Docket Nos. EPA-HQ-OAR-2006-0790,  
EPA-HQ-OAR-2002-0058 and  
EPA-HQ-OAR-2003-0119

**NACAA Comments on EPA Proposals for Reconsideration of the National Emission Standards for Hazardous Air Pollutants (NESHAP) for Industrial, Commercial and Institutional (ICI) Boilers under Section 112 of the Clean Air Act (CAA) and Regulations Limiting Emissions of Toxic and Criteria Air Pollutants from Commercial Industrial Solid Waste Incineration (CISWI) Units under Section 129 of the CAA**

Docket Nos. EPA-HQ-OAR-2006-0790; EPA-HQ-OAR-2002-0058;  
EPA-HQ-OAR-2003-0119

February 21, 2012

**Chart 1. PM Emissions (Lowest Test Result) for Fluidized Bed Coal-fired Units**

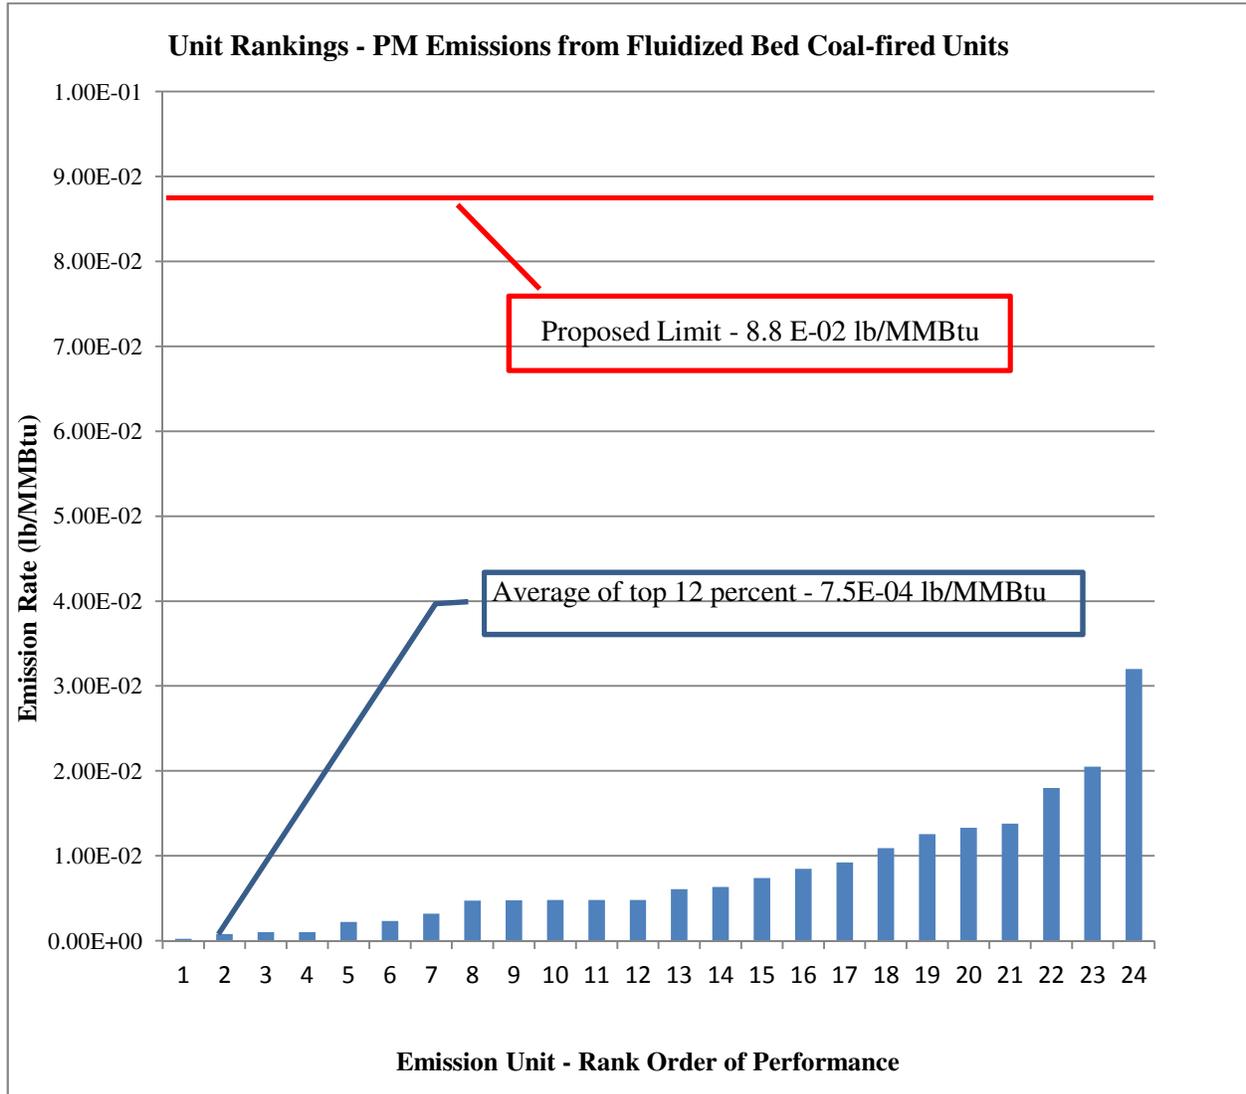
EPA has the means to objectively evaluate requests for subcategories and should do so for all subcategories incorporated in its rule. It should determine through the use of statistical techniques, such as a T-test of significance, that the emissions performance of each proposed subcategory is in fact significantly different from the broader category or subcategory of which it is a member. If a significant difference is shown, EPA should determine whether the difference is a function of the design of the combustion unit itself or is related to the prevalence of post-combustion controls that can be employed throughout the category. Where EPA determines that the emissions performance of the proposed subcategory is, in fact, significantly different from the broader category and is associated with the design of the combustion chamber itself, rather than post-combustion controls, EPA should compute the arithmetic average of the best performing unit(s). However, unless the proposed subcategory has sufficient data (nominally 50 data points) upon which to determine the variability of performance, EPA should apply the

**Figure 1. Log-normal Distributions**

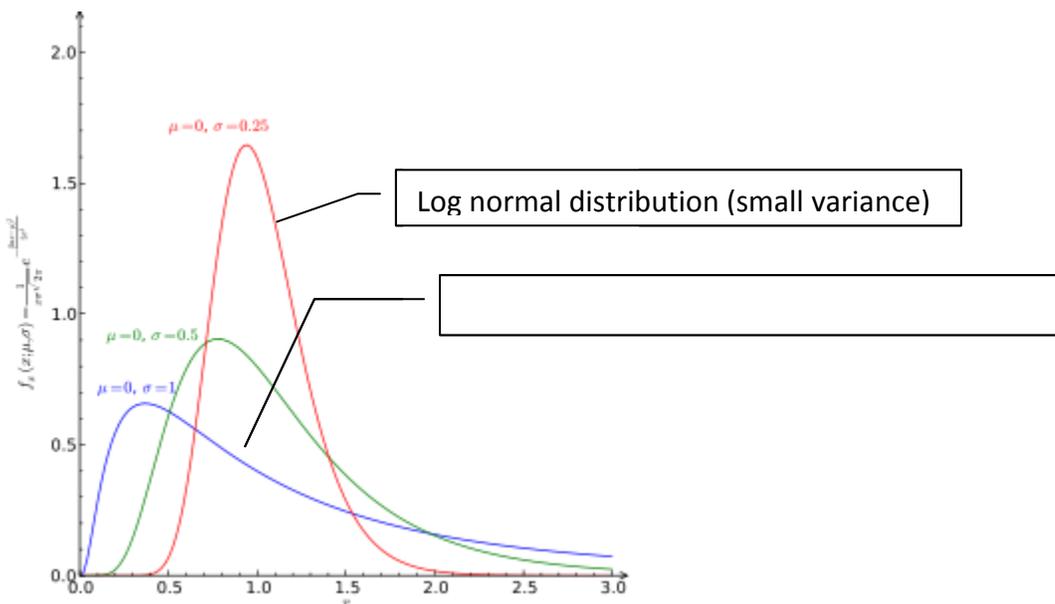
One feature of log-normal distributions is that they have “tails” that become very long as the variance increases. That is, the difference between the mean and the value that represents the 90<sup>th</sup> percentile probability is much greater where one assumes a log-normal distribution than otherwise. However, we know that the emission rate of specific pollutants, such as mercury (“Hg”), can never be larger than the amount of Hg in the fuel and that emission rates are also influenced by the operational characteristics of installed pollution control devices. Yet, EPA’s calculations routinely predict results that are inconsistent with these facts. They also lead to results, cited above, where the performance of the best performing unit is calculated to be worse than the average of the top 12 percent and where the calculated performance of the best units approximates the demonstrated performance of the worst units. These examples illustrate the point that in order to properly determine whether a particular statistical method is appropriate for a data set, one must determine whether the results of the method employed make sense. We submit that EPA’s decision to use the 99<sup>th</sup> percentile leads to unrealistically large calculated variations in performance of the best performing units, especially where the distribution is assumed to be log-normal and especially where the sample size is small so that relatively large variances are computed.

**Chart 3. Hg Emissions Data for Coal-fired Units**

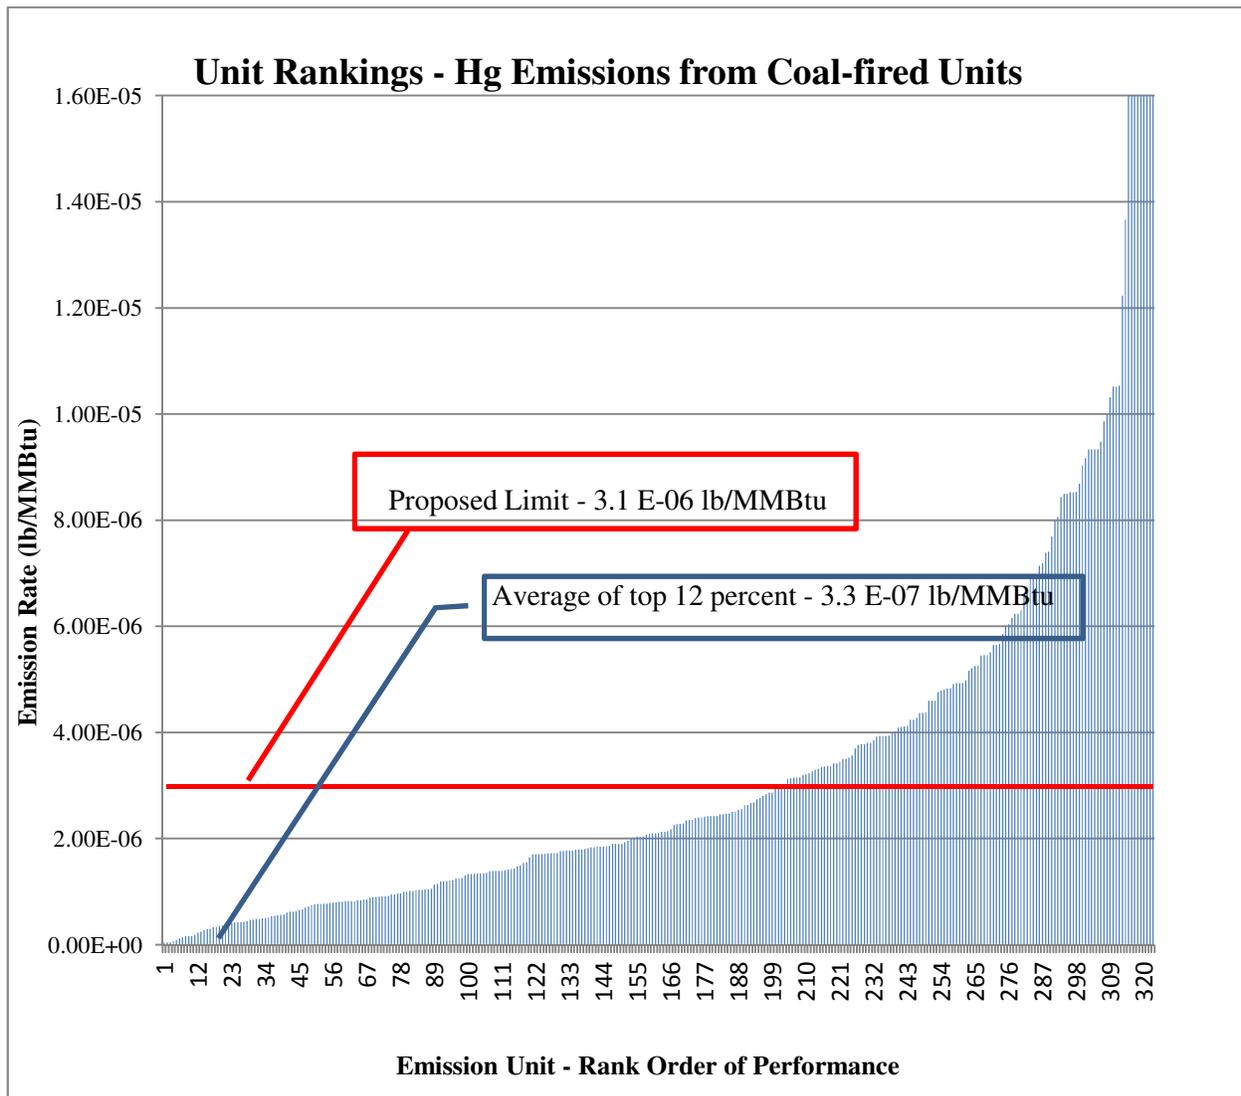
NACAA attempted to discern why EPA’s procedure generated such different results when the overall distribution of the Hg emissions data for coal and oil-fired units was so similar. The largest single reason for this vast difference appears to be a simple error in importing the data – EPA incorporates the emissions data for HCl instead of Hg into its UPL calculation.<sup>26</sup> With the correct data, EPA’s 99<sup>th</sup> percentile UPL calculation yields a MACT floor of  $4.58 \times 10^{-7}$  lb/MMBtu.

Chart 7h: Unit Rankings for CO from Light Liquid Units (Proposed Limit 7 ppm)<sup>64</sup>

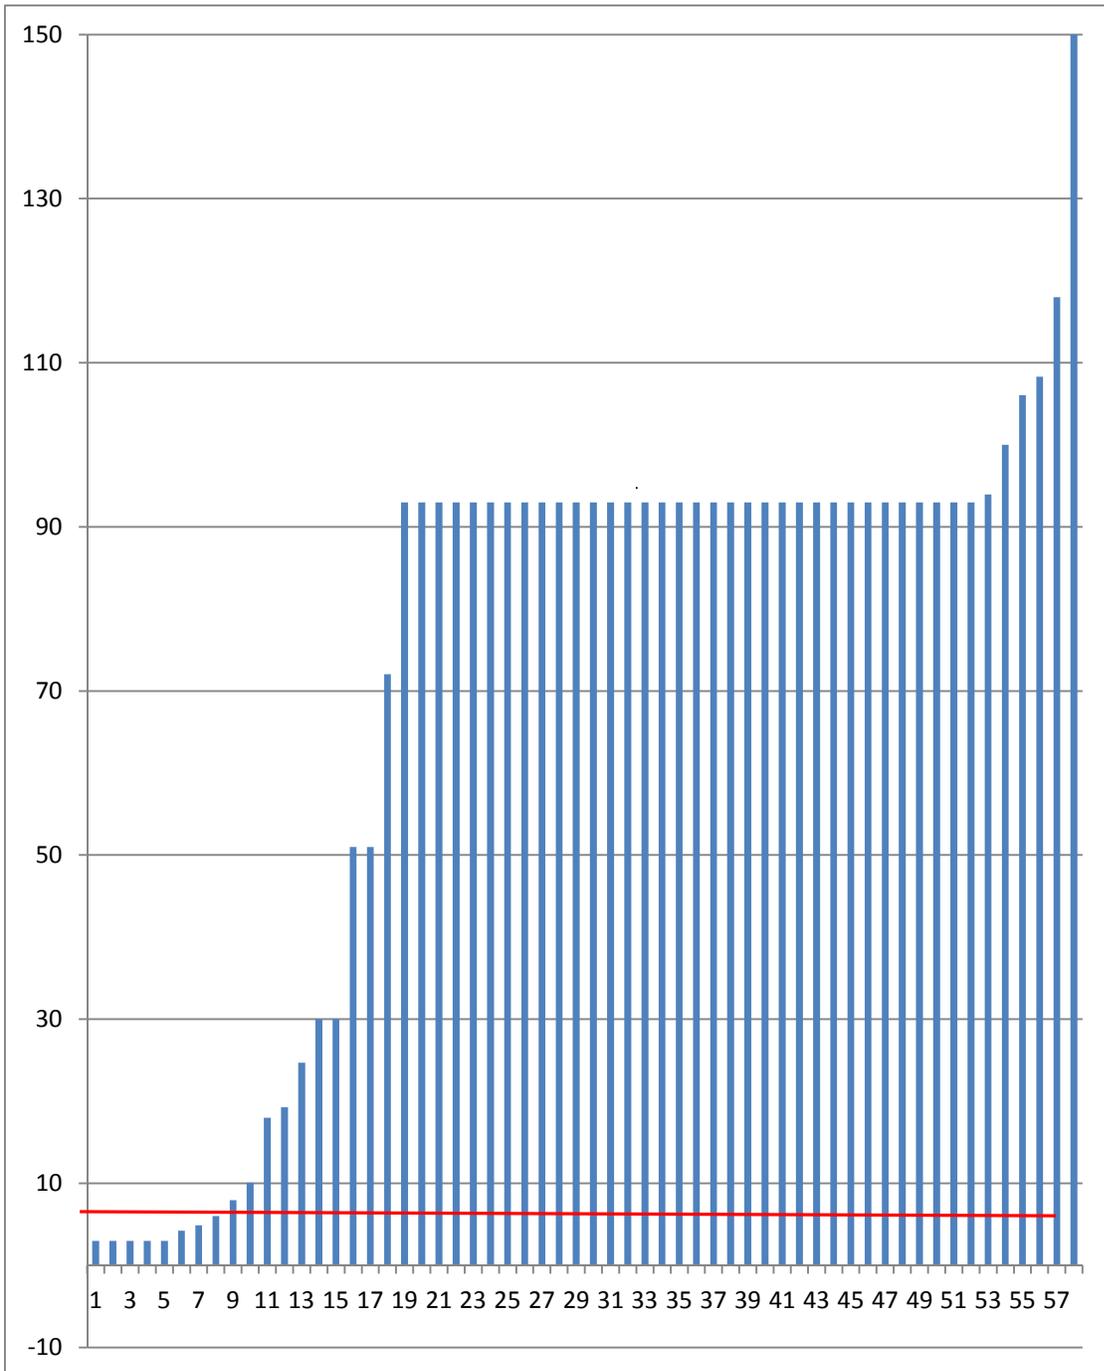
<sup>64</sup> The number of identical readings suggests a problem with this data set.
